UNITED STATES PATENT AND TRADEMARK OFFICE

APPLICATION NO.	FILING DATE	FIRST NAMED INVENTOR	ATTORNEY DOCKET NO.	CONFIRMATION NO.
10/699,208	10/31/2003	Leonard Stevens	64104-00002USPT	2784
7590 07/27/2004 CROWE & DUNLEVY, P.C. 20 NORTH BROADWAY SUITE 1800 OKLAHOMA CITY, OK 73102-8273			EXAMINER MENDOZA, MICHAEL G	
			ART UNIT 3731	PAPER NUMBER

Office Action Summary

DETAILED ACTION

Fig. 12

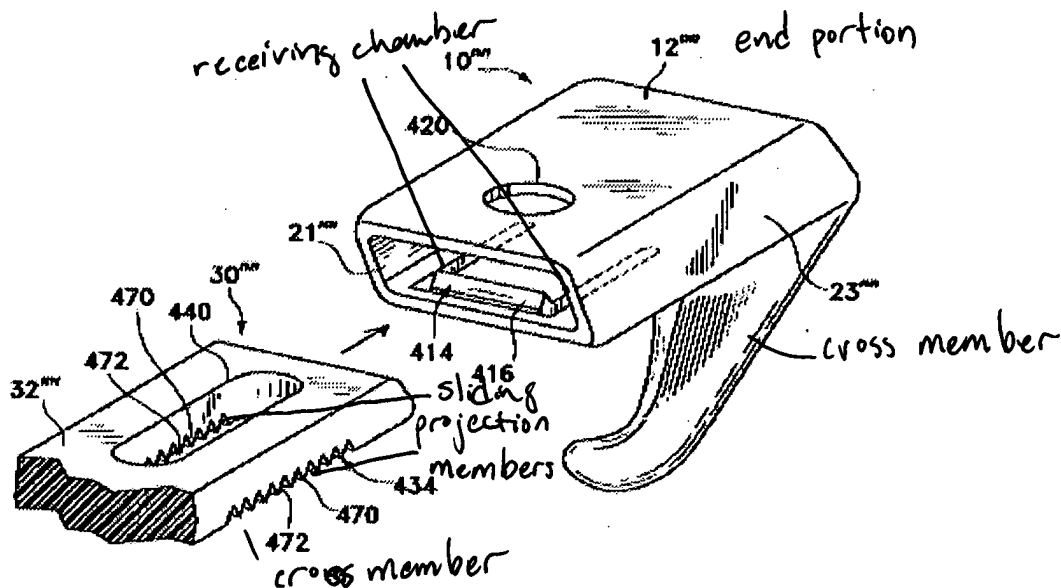
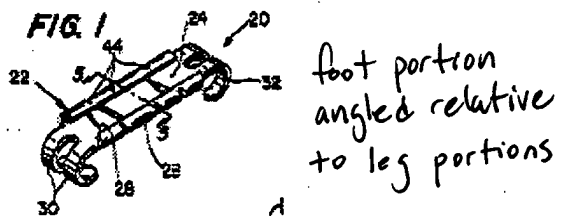
12. Regarding claims 1 and 2, Hogendijk et al. disclose in Fig. 12 the device comprising impermanently joined sliding (10''') and receiving (30''') attachment structures. Each structure has a cross member (see Fig. 12 inserted below) and an end portion (12 '''). Fig. 12 is a structurally analogous embodiment of Fig. 1 (col. 3, lines 65-67), which more clearly shows the receiving attachment structure's end portion (32) and the plurality of sternum engagement surfaces (bottom of 17 and 72, 20, 22, 40, 42). Hogendijk et al., however, disclose in Fig. 1 only one foot (20, 40) and leg (16, 36) portion on each structure and not a plurality of foot and leg portions on each structure. Crossett et al. disclose in Fig. 4 a plurality of foot (36, 38) and leg (30, 32) portions on each structure. This additional structure is simply a duplication of parts, and it is well known to add another leg or foot portion to enhance the securement of the sternum clamp to the sternum. It would have been obvious to one having ordinary skill in the art at the time of the invention to add another leg and foot portion to each structure to strengthen attachment of the device to the sternum.

13. Regarding claim 2, Hogendijk et al. disclose in Fig. 12 the receiving structure (30''') comprising a resiliently tensioned locking member with angularly disposed teeth

like structures (47) outwardly positioned at first (bottom 470) and second (top 470) ends of the locking member. Hogendijk et al. further disclose a securing aperture (440) substantially centered there between.

20. Regarding claim 12, Hogendijk et al. disclose in Fig. 12 a method comprising positioning sliding (30''') and receiving (10''') attachment structures about a respective sternal half (col. 6, lines 59-64). The opposed sliding and receiving attachment structures can be aligned for insertion of sliding structure projection members (see Fig. 12 below) into receiving chambers (located on each side of 416) of the receiving attachment structure. Fig 1, of which Fig. 12 is a structurally analogous embodiment

Fig. 9

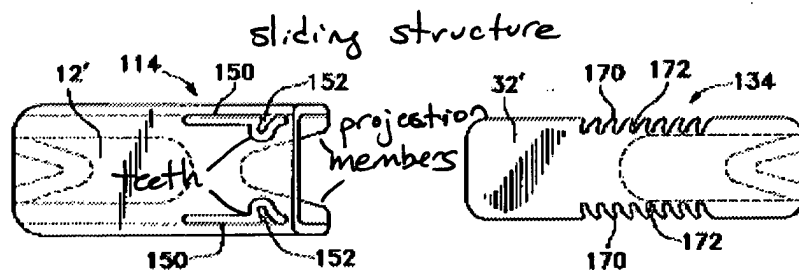
14. Regarding claims 1, 3-10, 12, and 15, Hogendijk et al. disclose in Fig. 9 the device comprising impermanently joined sliding (114) and receiving (134) attachment structures. Each structure has a cross member (12', 32') and an end portion (the left and right ends of 12', 32'). Fig. 1 of which Fig. 9 is a structurally analogous embodiment (col. 3, lines 54-56), shows the plurality of sternum engagement surfaces (bottom of 17 and 72, 20, 22, 40, 42). Hogendijk et al., however, disclose in Fig. 1 only one angled foot (20, 40, the foot is angle with respect to the leg) and leg (16, 36) portion on each structure and not a plurality of foot and leg portions on each structure. Crossett et al. disclose in Fig. 4 a plurality of foot (36, 38) and leg (30, 32) portions on each structure. This additional structure is simply a duplication of parts, and it is well known to add another leg or foot portion to enhance the securement of the sternum clamp to the sternum. It would have been obvious to one having ordinary skill in the art at the time of the invention to add another leg and foot portion to each structure to strengthen attachment of the device to the sternum.

15. Regarding claim 3, Hogendijk et al. disclose in Fig. 9 the sliding structure (114) comprising a plurality of projection members (see Fig. 9 below) with angularly disposed teeth like structures (152) inwardly positioned on each innermost surface of each projection member.

17. Regarding claim 7, Hogendijk et al. disclose in Fig. 9 the receiving attachment structure (134) comprising a securing means (170) to facilitate the operative securing of the structures to one another. The teeth (170) of one structure engage the teeth (152) of the other structure to secure the structures to one another.

22. Regarding claims 15 and 17, Hogendijk et al. disclose in Fig. 9 the device wherein the securing means (170) may be removed to facilitate immediate device disengagement.
